# **SECTION 4.55 (2) MODIFICATION**

DA2015/177/2
DA & Property:	40-42 Madeline Street Strathfield South- LOT 24 DP
	1200563
Proposal:	S4.55 (2) Modification Application for alterations and
Fioposal.	additions to an approved materials recycling facility.
Applicant:	J Cosgrove
Owner:	LC Investment (Australia) Pty Ltd
Date of lodgement:	19 November 2021
Notification period:	24 November – 14 December 2021
Submissions received:	3
Assessment officer:	J Gillies
Estimated cost of works (original):	\$16,850,000.00
Modification cost of works:	\$665,000.00
Zoning:	IN1-General Industrial - SLEP 2012
Heritage:	No
Flood affected:	Yes
Is a Clause 4.6 Variation Proposed:	No
<b>RECOMMENDATION OF OFFICER:</b>	Approval

Figure 2 – Proposed Site Plan

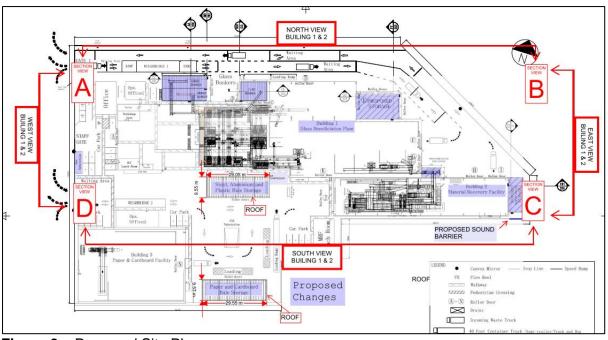
Condition to be amended	Modifications (as proposed by Applicant)	Council comments
Condition 1 – Plans	Applicant's statement:	Council agrees with the description of the
	The approved site plan and elevations would be updated to reflect the following physical changes across the site:	proposed changes and need for an amendment to
	<ul> <li>Revision to the site parking layout (with no change to the total number of parking bays),</li> </ul>	Condition 1 to reflect the new site layout as per the submitted Site Plan and Elevations.

• Relocation of substation to the front of the site,	
	• Change the use of two existing external storage bunkers approved for glass storage, for the storage of baled paper and cardboard, and baled steel, aluminium and plastics,

• Construction of a new glass storage bunkers enclosure on the northern side of Building 1,	
	<ul> <li>Reconfiguration of site uses across existing buildings, including:</li> </ul>	
	<ul> <li>Building 1 – Materials Recovery Facility output consolidation and glass beneficiation plant,</li> </ul>	
	<ul> <li>Building 2 – Main Materials Recovery Facility processing line,</li> </ul>	
	<ul> <li>Building 3 – Paper and Cardboard Recovery.</li> </ul>

Figure 4 – Approved site layout (DA2015/177)

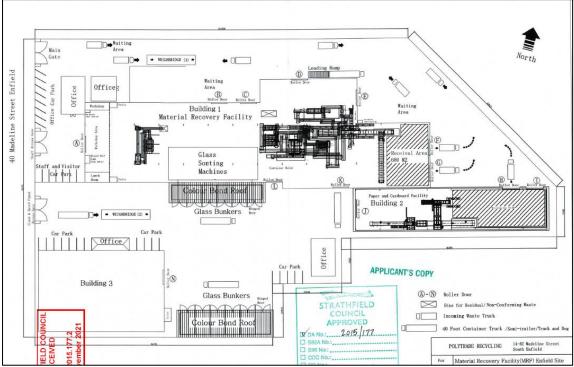
Figure 3 below shows the approved site layout. As noted in the image, the following uses exist across the site:

- MRF within building 1,
- PCF within Building 2,
- No approved uses within Building 3,
- External storage bunkers,
- Weigh bridges,
- Ancillary offices,
- 29 parking spaces, and
- On-site substation.
